# Product Change Notification

## 112375 - 00

**Change Notification #:** 112375 - 00  
**Change Title:** Intel® Server System P4308IP4LHJC and P4304SC2SFEN  
PCN 112375-00, Product Design Update BIOS/ME/BMC/FRUSDR Firmware and Package Regulatory Label with Perchlorate Statement  
**Date of Publication:** June 24, 2013

The picture below shows the stand-off pre-installed on the server board:

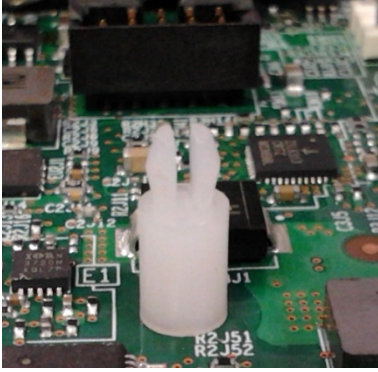
1. Intel® server board S2600IP Printed Board Assembly (PBA) revision will be updated from G20993-303 to G20993-305 with below changes:
  - a) Update the BIOS from revision 01.02.0005 to 01.06.0001.
  - b) Update the Manageability Engine (ME) firmware from revision 02.01.05.091 to 02.01.05.107.
  - c) Update the Integrated Baseboard Management Controller (BMC) firmware from revision 01.00.2812 to 01.16.4010.
  - d) Update the FRUSDR from 1.03 to 1.09.
2. A plastic stand-off will be pre-installed on the server board. Users can install an eUSB SSD device on the stand-off.

The picture below shows what the stand-off looks like:
